Public Meeting – Monday, October 25, 2021 at 7:00 PM Zoom MEETING MINUTES

IQHQ Alewife Park – Redevelopment and Restoration 1 Alewife Center

re: Notice of Intent IQHQ Alewife Park 1 Alewife Center Cambridge, MA 02140

TO:	Alewife Neighbors, Inc.
FROM:	Kevin Trainer and K. James Taylor, Jr.
DATE:	October 25, 2021
SUBJECT:	Notice of Intent Review
	Alewife Park (Former W.R. Grace & Co. Disposal Site)
	Cambridge, MA

Flooding Contours from Cambridge GIS

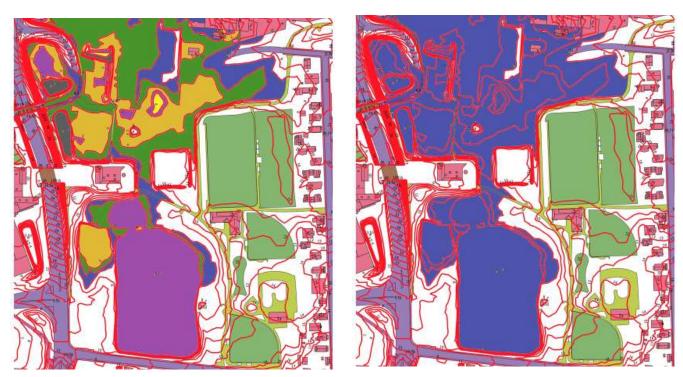
Another aspect of the plans we would like the Commission and the developer to consider is using a portion of the southwest corner of Jerry's Pond for flood compensation at the upper elevation increment. This area currently has existing paving from a former development, thereby limiting vegetation in the area. Depaving would allow for better soil conditions for future habitat.

Although the NOI narrative indicates Jerry's Pond is in a different subwatershed than the majority of the proposed development area, Jerry's Pond does connect to the rest of the site during the 100-year storm event, as noted by GeoInsight. The normal elevation of Jerry's Pond is below the elevation of flooding that would connect the site. By only digging out this area of higher elevation next to Jerry's Pond down to the elevation of the highest increment below the Base Flood Elevation for the site, the Pond itself would not be disturbed, so there would be no impact from disruption to sediment or other pond wildlife.

Flooding of a 100-year storm showing connection of subwatersheds

Yellow areas show approximate extent of relocation needed near Jerry's Pond to avoid removal of clusters of trees in the contaminated area in the blue oval.
